**RE: Epiq Estate (Pacific Pines) Lennox Head (MP07\_0026 MOD 7)**

**Enclosure: Detailed BCD Comments – Modification 7 for the Epiq Estate (Pacific Pines) Residential Subdivision at Lennox Head**

## **Attachment 1: Detailed BCD Comments – Modification 7 for the Epiq Estate (Pacific Pines) Residential Subdivision at Lennox Head**

**Figure 1. Stormwater Concept Plan in the Approved Modified Project Plan for MOD 4 compared to the one labelled P4- Stage 1 Stormwater Concept Plan REV F' in the 15 June Additional Information.**

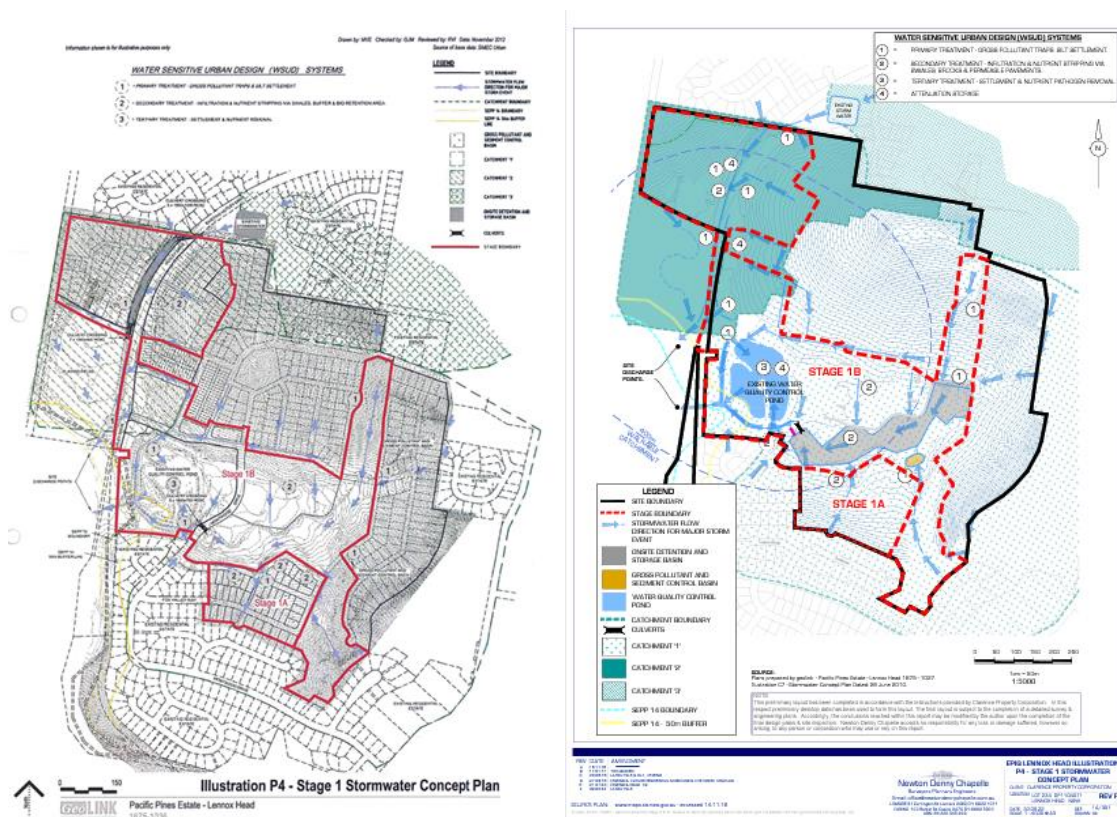
The *June 15 Additional Information* includes a different C7- Stormwater Concept Plan (REF F) to the one that was part of the MOD 4 approval (see comparison in Figure 1 below). We question if this is the correct and currently approved Stormwater Concept Plan (SCP) or if the MOD 5 and MOD 6 SCPs were incorrect as they reverted to an earlier version of the SCP, noting REF F describes the incorrect layout for Superlot 5.

7. The proponent should clarify the status of the Stormwater Concept Plan Illustration C7 and ensure the correct and current one is included in all relevant revised documentation.

**Figure 3. Extracts from Civil Services Plan Dwg No. 14351-S5-DA-CI-21 prepared by Newton Denny Chapelle for Clarence Property, HumeCeptor locations circled in blue.**

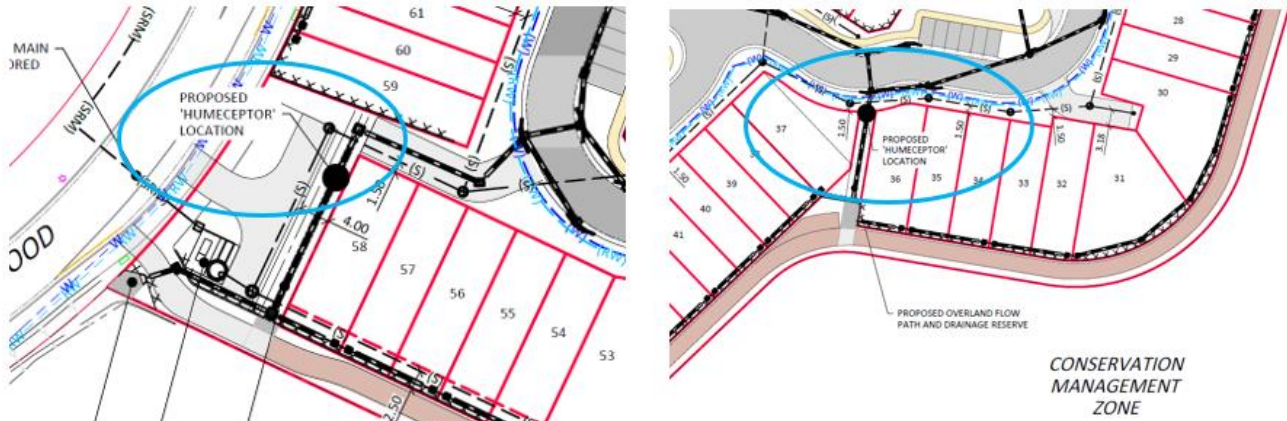
consultant demonstrated that it was not possible to provide stormwater detention basins along the southern edge of the development where it adjoins the CMZ due to the site levels. Instead, it was proposed to include two HumeCeptor stormwater quality treatment units to treat stormwater for the north-east and south-west catchments (ref: Civil Services Plan Dwg No. 14351-S5-DA-CI-21) (see Figure 3 below). This outcome was the result of the onsite meeting in October 2020 and detailed discussions with the stormwater consultant.

However, the Site Plan in Attachment 2 in *8 Feb 2022 Updated Subdivision Design and Additional Information* (DWG 140351-S5-DA-AA-01) does not show the HumeCeptors and now depicts three discharge points that stop just short of the CMZ (see Figure 4 below). We question these discrepancies.

9. To address inconsistencies in documents provided the proponent should explain and correct differences in the proposed stormwater treatments or revise these as necessary following the above assessments.
